UNITED STATES
NUCLEAR REGULATORY COMMISSION
REGION I
631 PARK AVENUE
KING OF PRUSSIA, PENNSYLVANIA 19406

Docket Nos. 50-352
50-353

IE Bulletin No. 80-20
Page 1 of 2

FAILURES OF WESTINGHOUSE TYPE W-2 SPRING RETURN TO NEUTRAL CONTROL SWITCHES

FIGURE 1

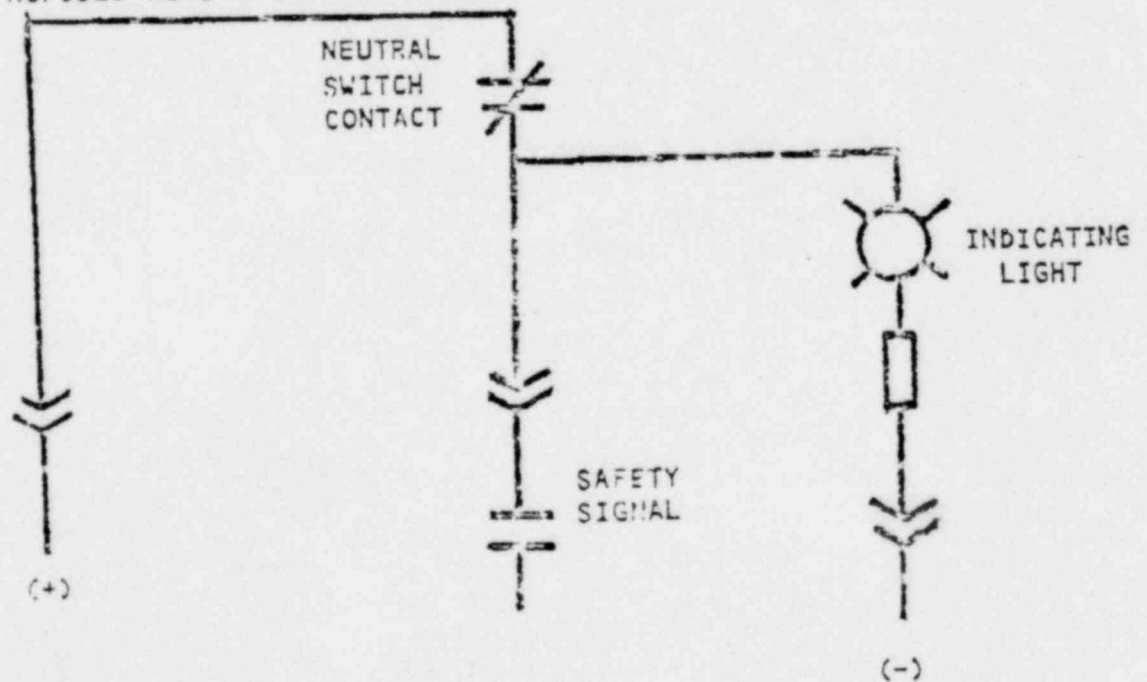
A review of this matter by Westinghouse led to the issuance of NSD Technical Bulletin No. NSD-TB-80-9 to the utility owners of all Westinghouse operating plants. The recommendations contained in the Westinghouse technical bulletin include: (i) testing the neutral position contacts of the subject W-2 switches for continuity, and (ii) rewiring of the indicating light circuit to permit the early detection of a neutral contact failure as shown in Figure 1.

Depending on how the indicating light circuit is wired, loss of continuity thru the neutral position contact of a W-2 switch could remain undetected until the equipment associated with the switch were called upon to operate. Since such a failure would be equivalent to by-passing the system associated with the switch, consideration should be given to rewiring the switches used in safety-related applications as shown in Figure 1. Such rewiring would provide an acceptable means for detecting contact failure, provided the indicating light is in the control room and readily visible by the operator. If the indicating light is not so located, consideration should be given to annunciating the neutral position contact failures at the control room to alert the operator of the inoperable status of a safety-related system. In addition, consideration should be given to adding redundant contacts to the W-2 switches or to replacing the W-2 switches with others having a more positive contact wiping action.

3. Licensees of operating plants and holders of construction permits shall describe the longer term corrective measures planned and the date by which such measures will be implemented by actual installation or by design change, as appropriate. As a minimum, the longer term corrective measures should include rewiring the indicating light as shown in Figure 1 provided the light is readily visible to the control room operator. If not, failures of the neutral position contacts should be annunciated in the control room.

REWIRING OF INDICATING LIGHT CIRCUIT OF W-2 SWITCHES
AS RECOMMENDED BY WESTINGHOUSE TECHNICAL BULLETIN NSD-TB-80-9
